Sundry Print Report

Sundry ID: 2754818

Type of Action: APD Change

Procedure Description: Mewbourne Oil Company requests variances to perform offline cementing and break testing on the following wells: JUDGE 3/4 FED COM 626H JUDGE 3/4 FED COM 628H SCREAMING EAGLES 9/7 FED COM 711H SCREAMING EAGLES 9/7 FED COM 713H FOREIGNER 33/4 FED COM 528H Procedures are detailed in the attachments.

Figure 1. BOP diagram

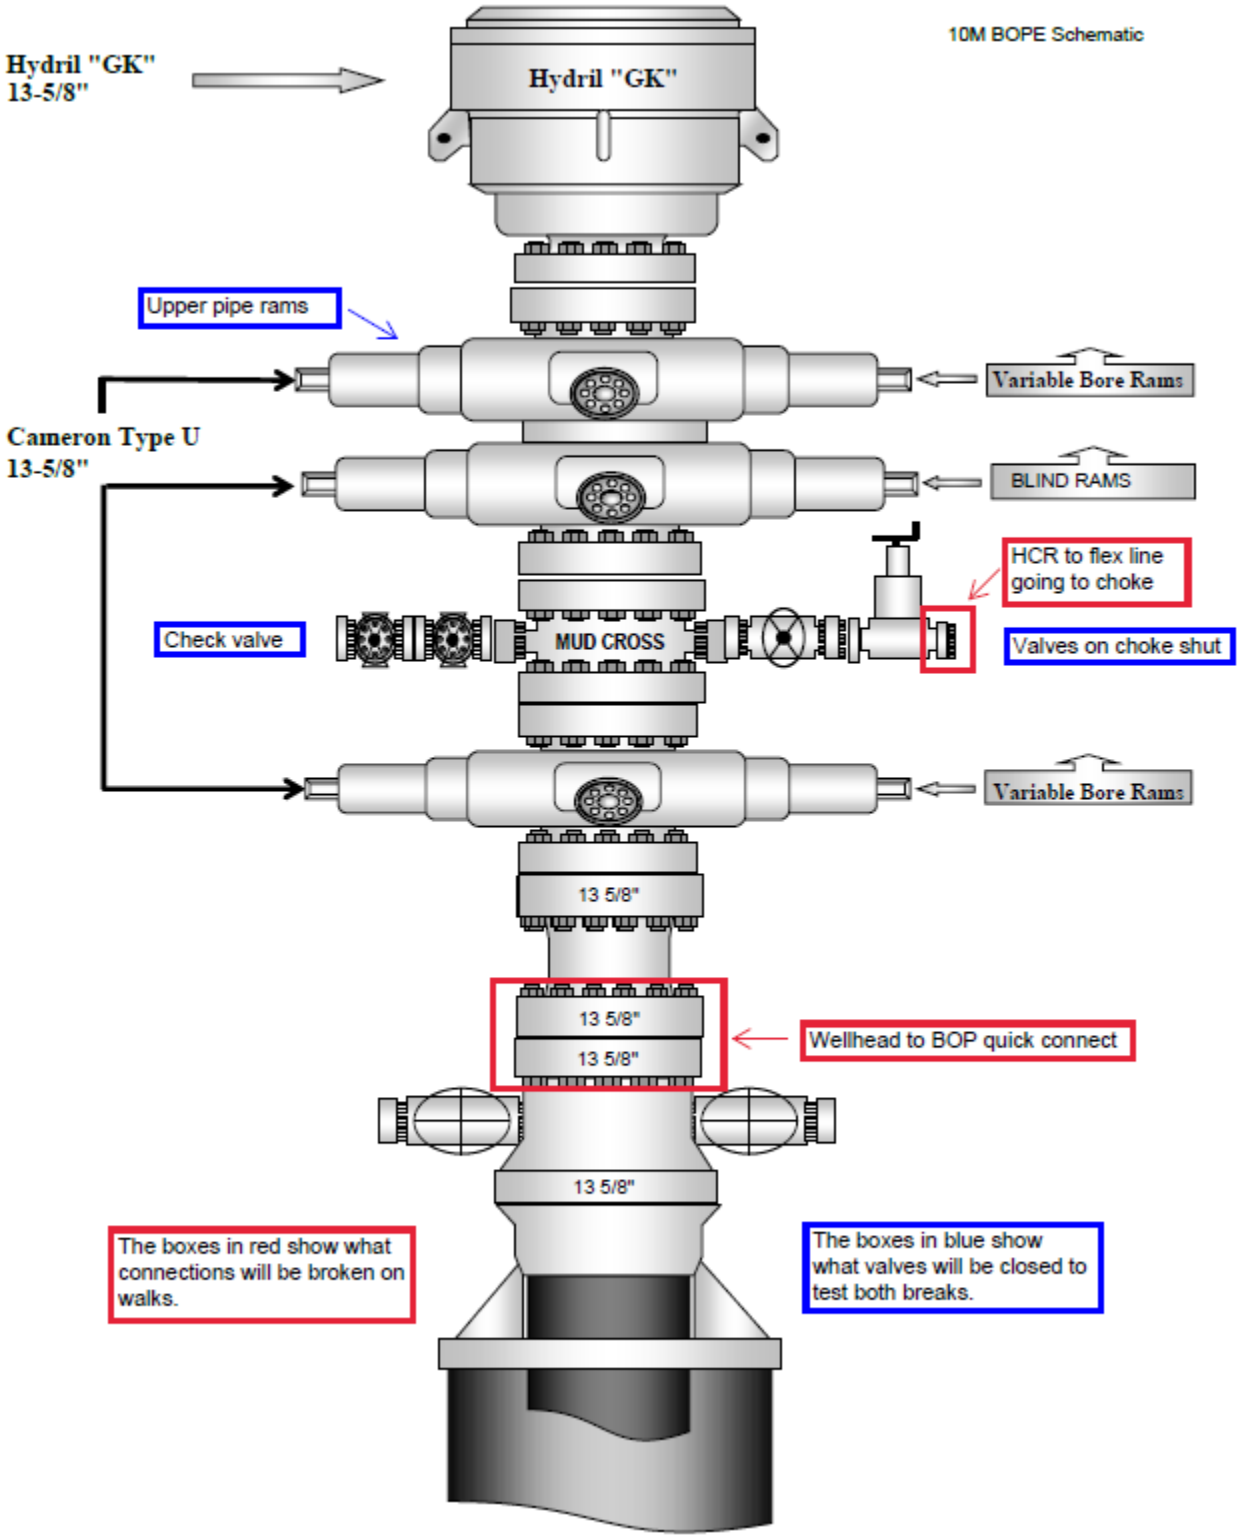
2. After the well section is secured and the well is confirmed to be static, the BOP will be disconnected from the wellhead and walked with the rig to another well on the pad. Two breaks on the BOPE will be made (Fig. 1).

9. A test will then be conducted against the upper pipe rams and choke, testing both breaks (Fig. 1 & 2).
10. The test will be held at 250 psi low and to the high value submitted in the APD, not to exceed 5000 psi.

Figure 5. Cactus 5M wellhead with BOP quick connect

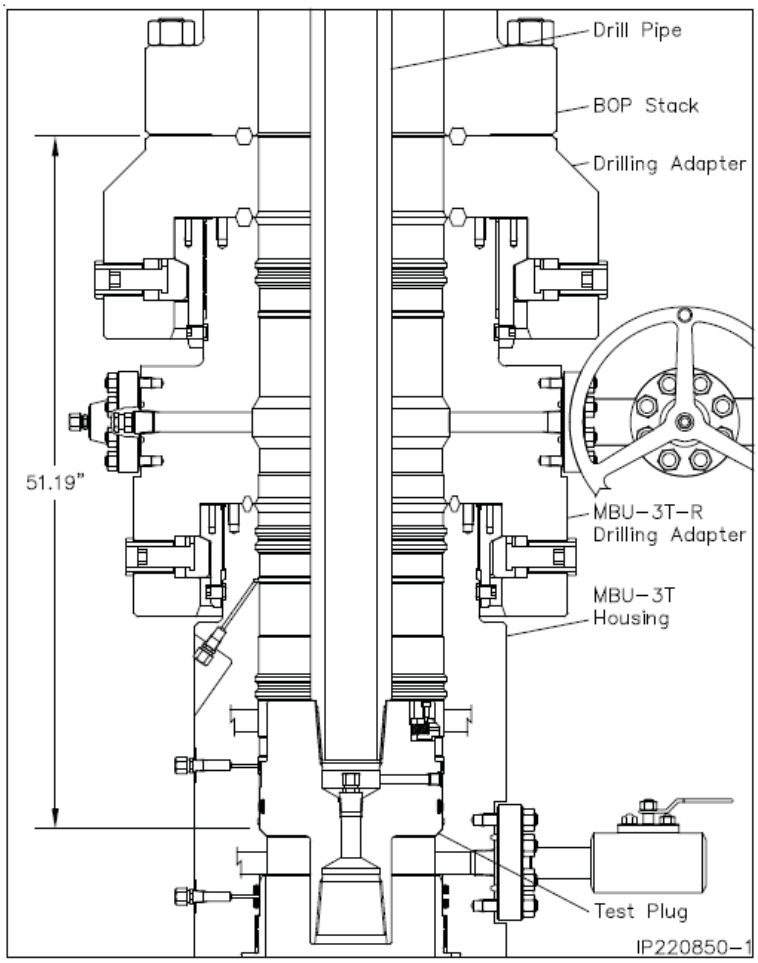
- Connection between the flex line and the HCR valve
   - Connection between the wellhead and the BOP quick connect (Fig. 5 & 6).
3. A capping flange will be installed after cementing per wellhead vendor procedure & casing pressure will be monitored via wellhead valve.

Figure 1. Cactus 13 3/8" 5M offline cementing tool. Pressure rating limited by the lesser of 5M tool rating or the 13 3/8" pup joint and casing.

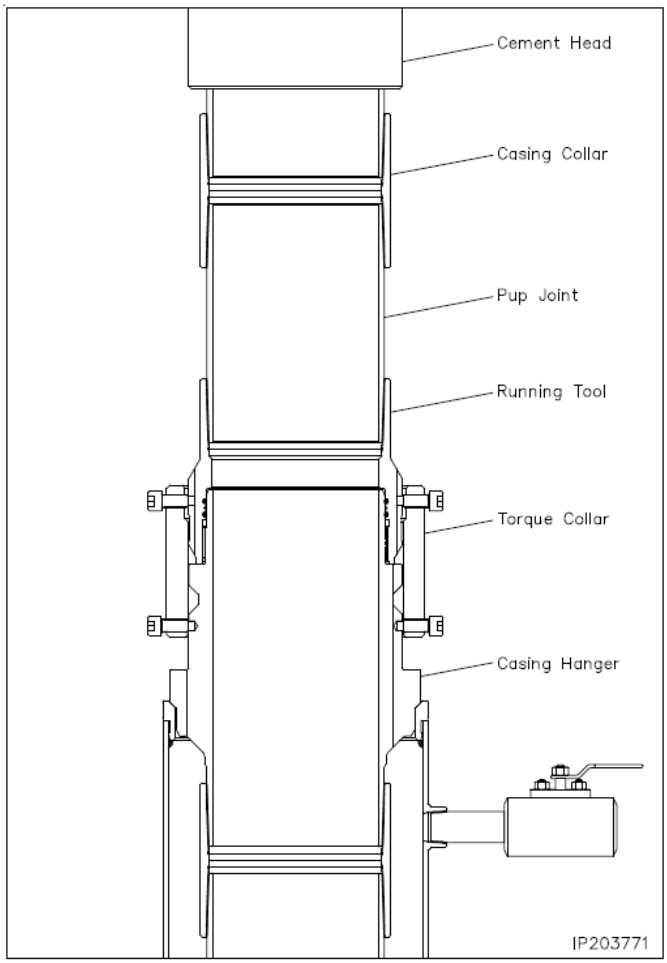
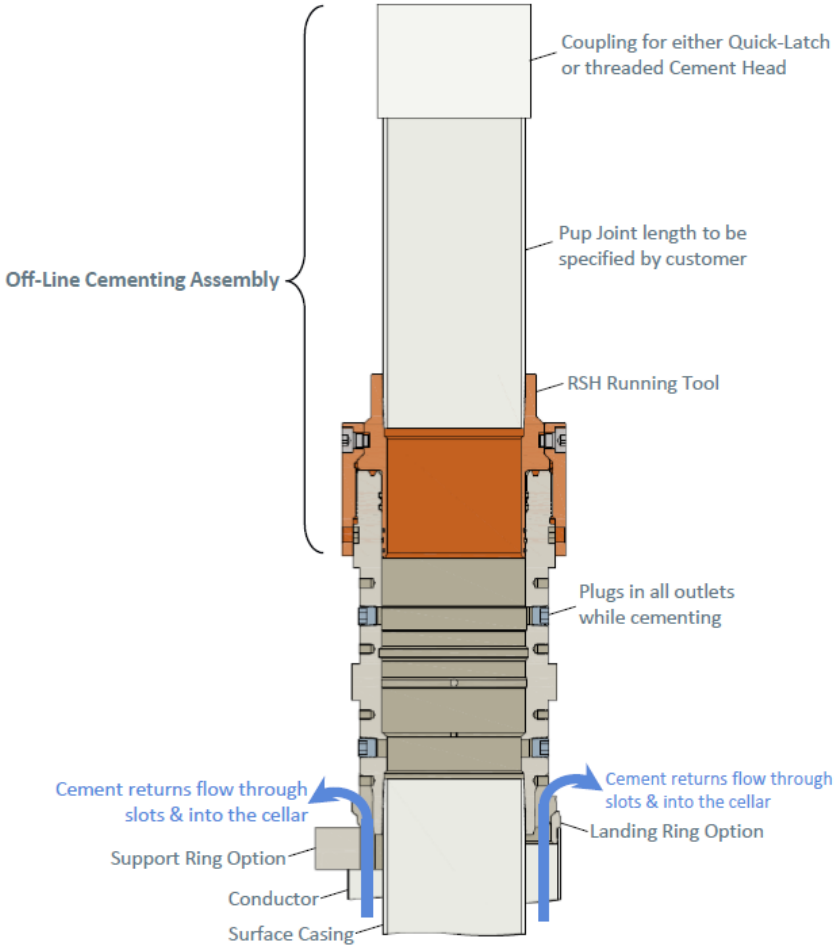
9. Make up offline cement tool with forklift per wellhead manufacturer (Fig. 1 & 2).
10. Make up cement head on top of offline cement tool with forklift.

Figure 3. Cactus 9 5/8" 5M offline cementing tool. Pressure rating limited by the lesser of 5M tool rating or the 9 5/8" pup joint and casing.

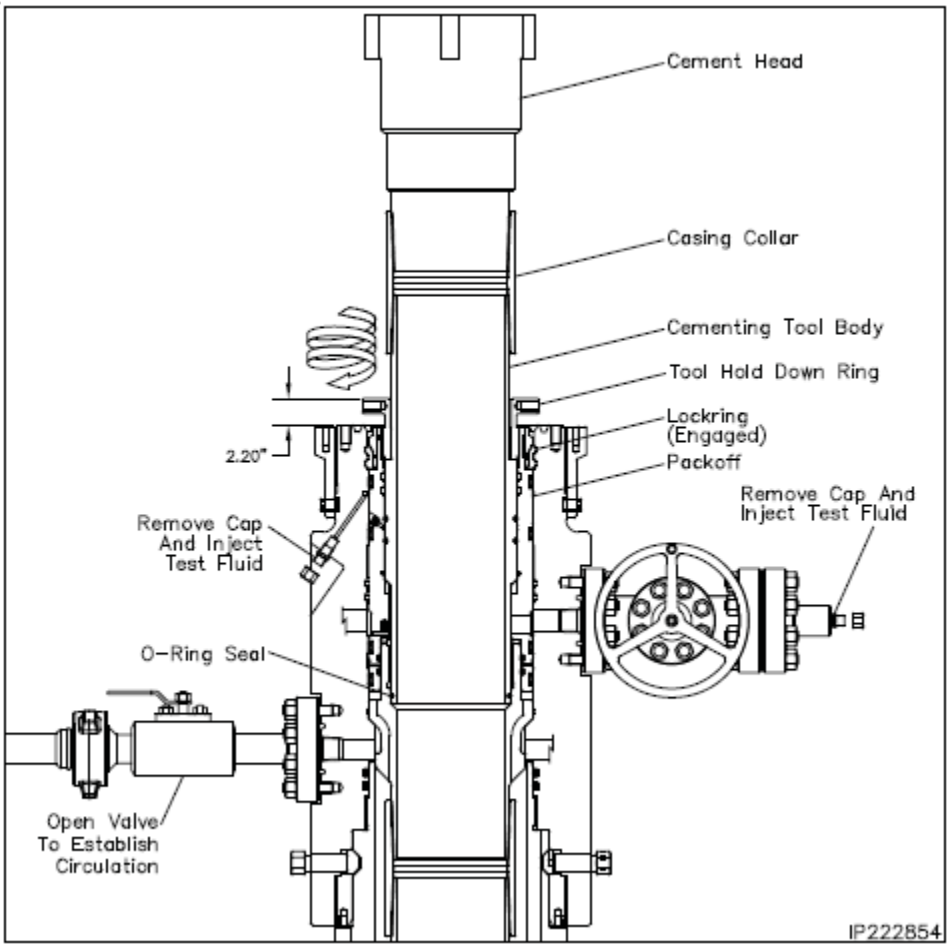
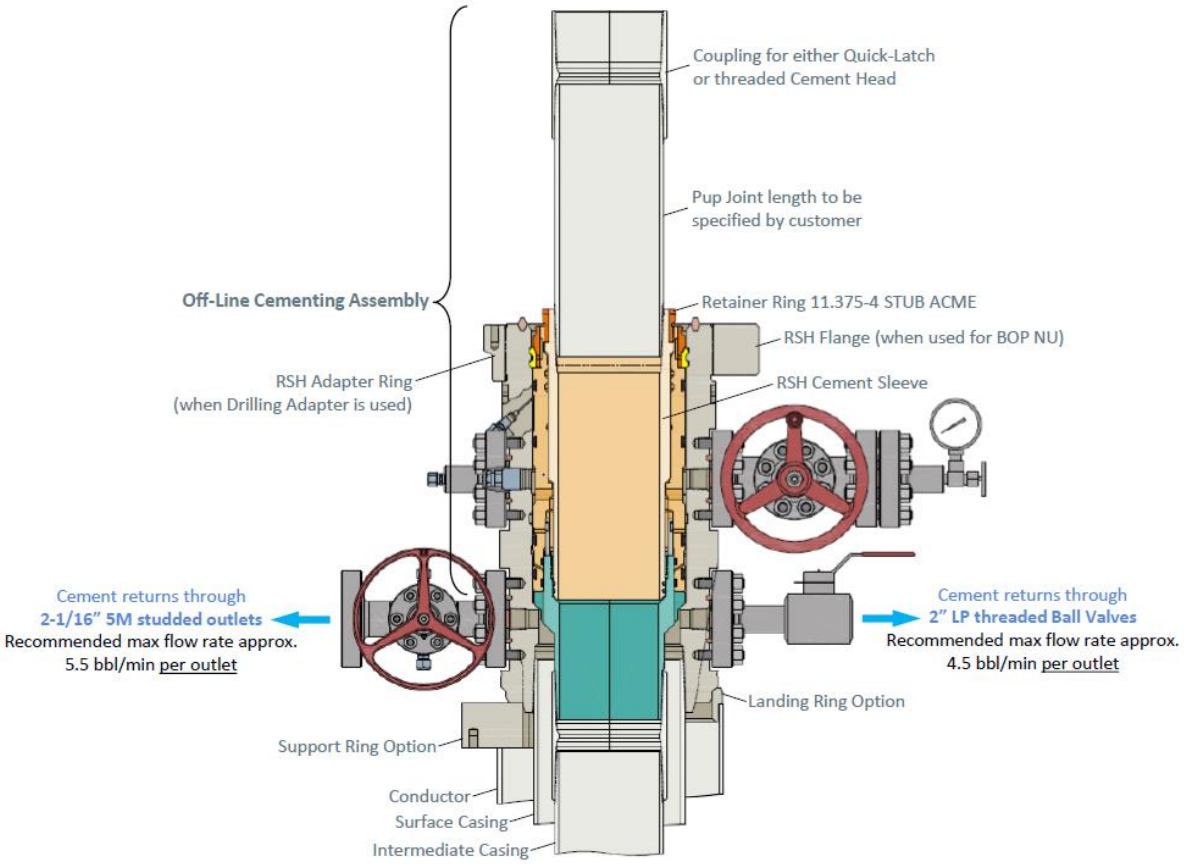
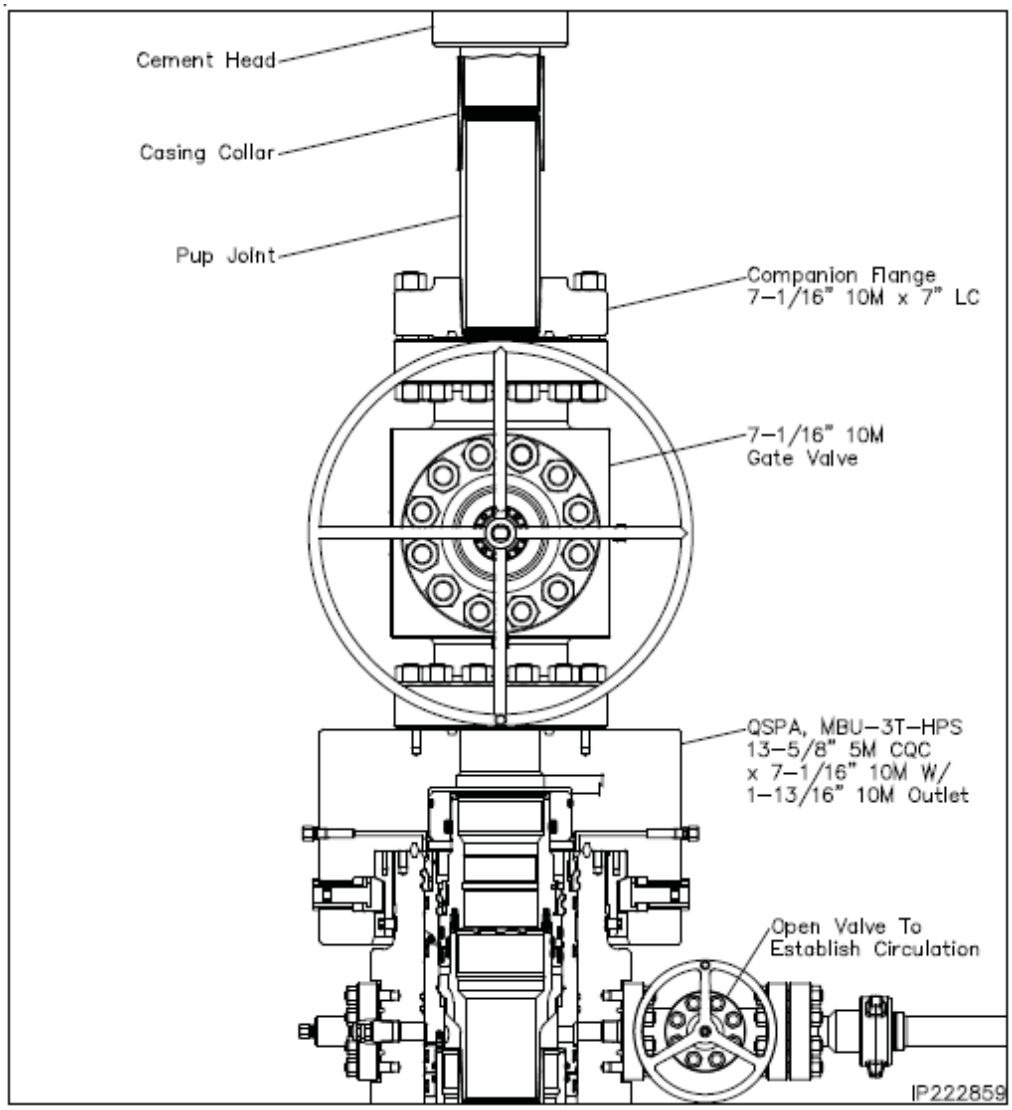
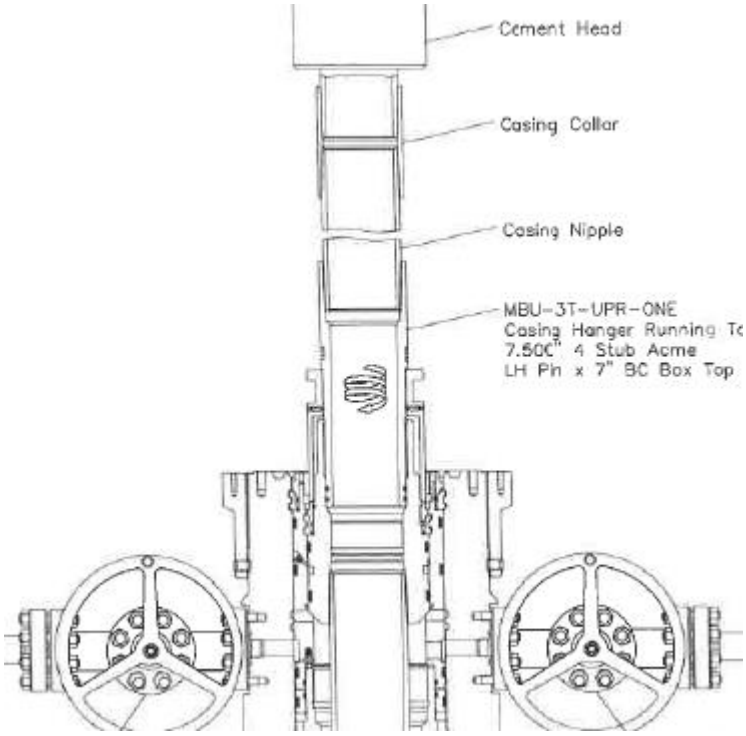
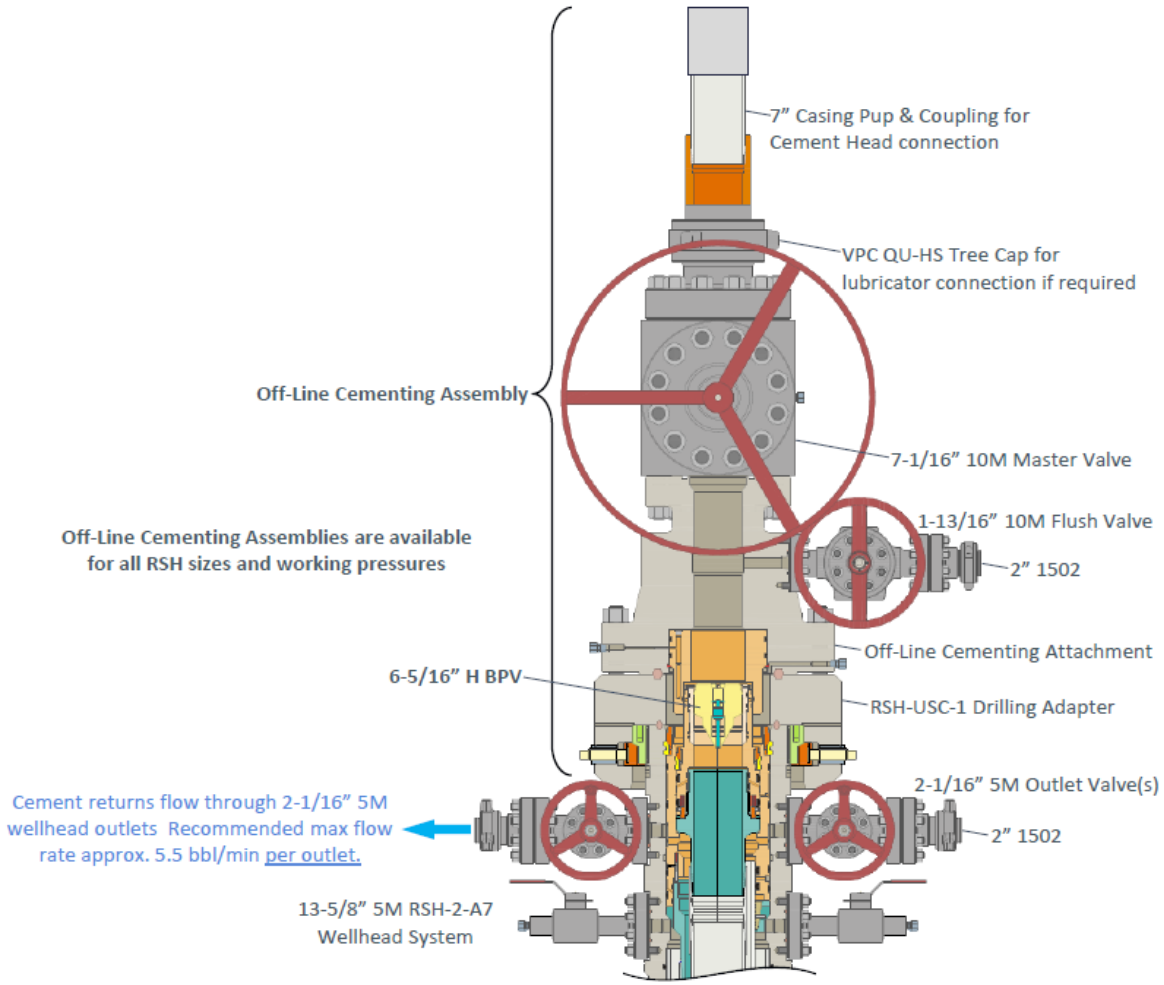
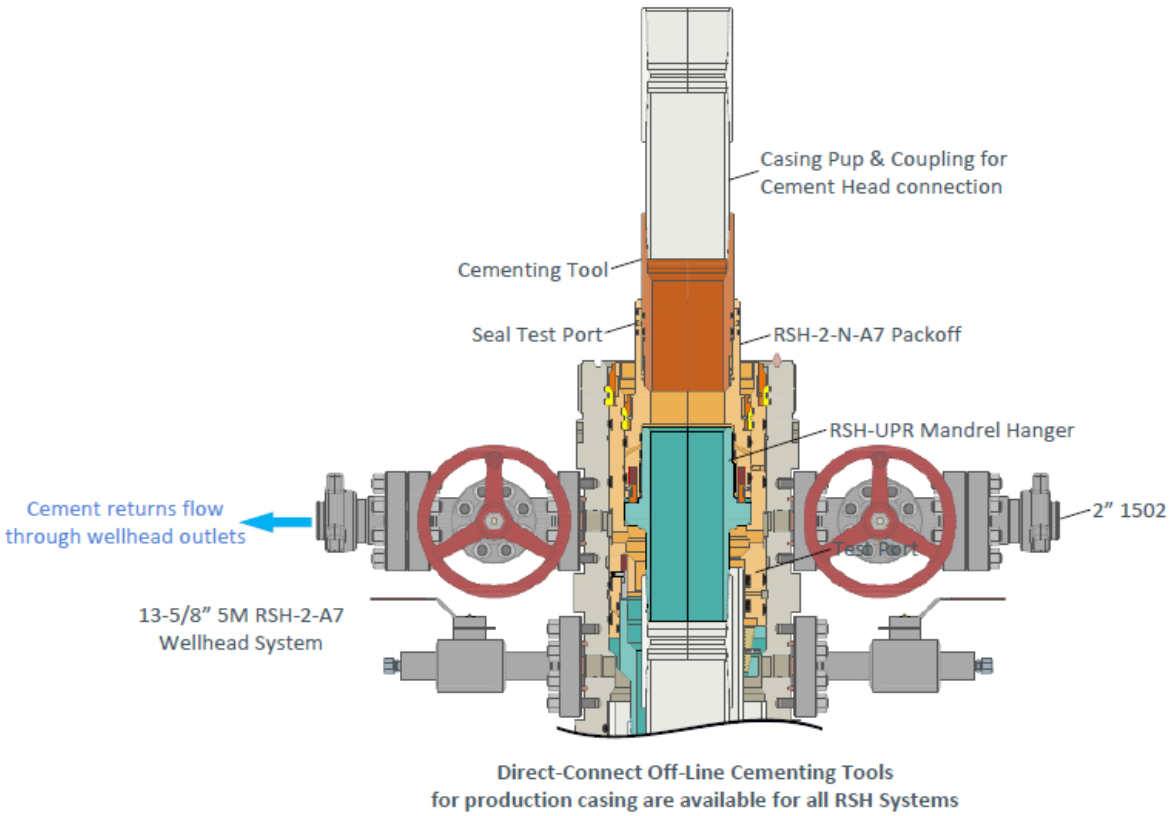
10. Make up offline cement tool using forklift per wellhead manufacturer (Fig. 3 - 8).
11. Make up cement head on top of offline cement tool.
12. Commence cement operations.

Figure 9. Five valve 15k choke manifold.

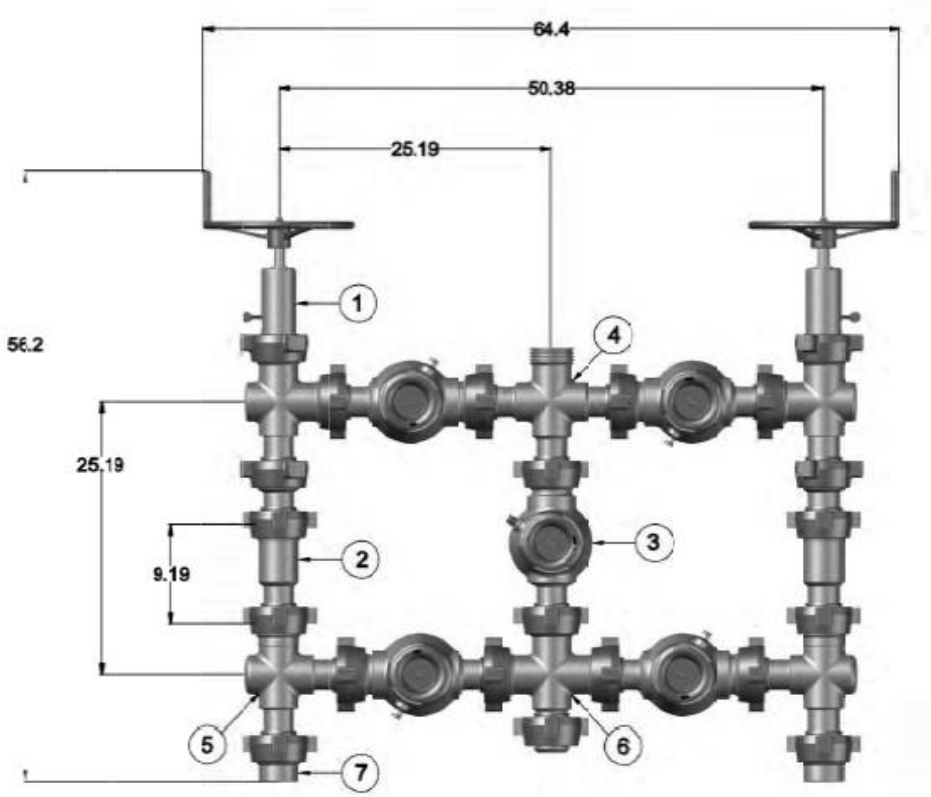
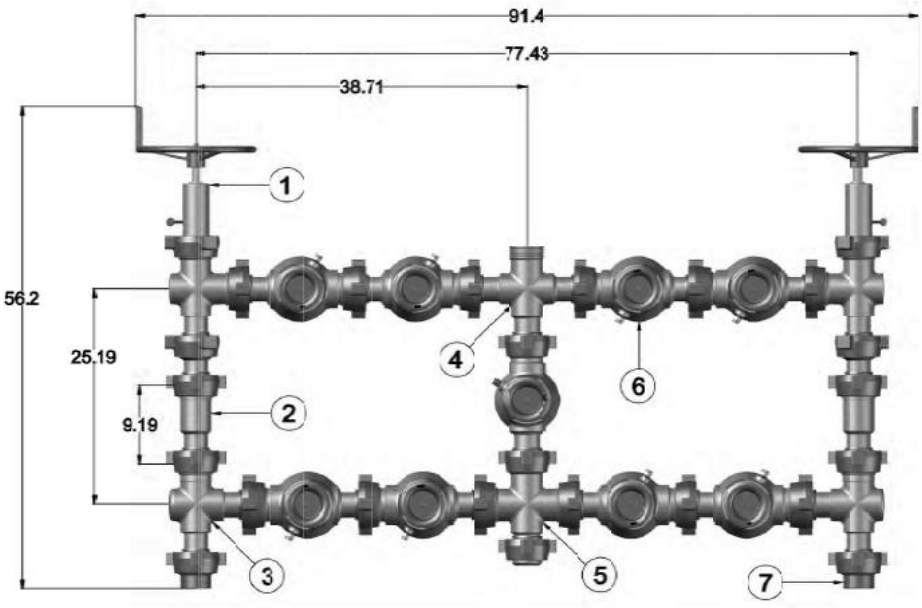
- Pressure build up in annulus before cementing
  - Contact BLM if a well control event occurs.
  - Rig up 3rd party pump or rig pumps to pump down casing and kill well.
  - Returns will be taken through the wellhead valves to a choke manifold (Fig 9 & 10).
  - Well could also be killed through the wellhead valves down the annulus.
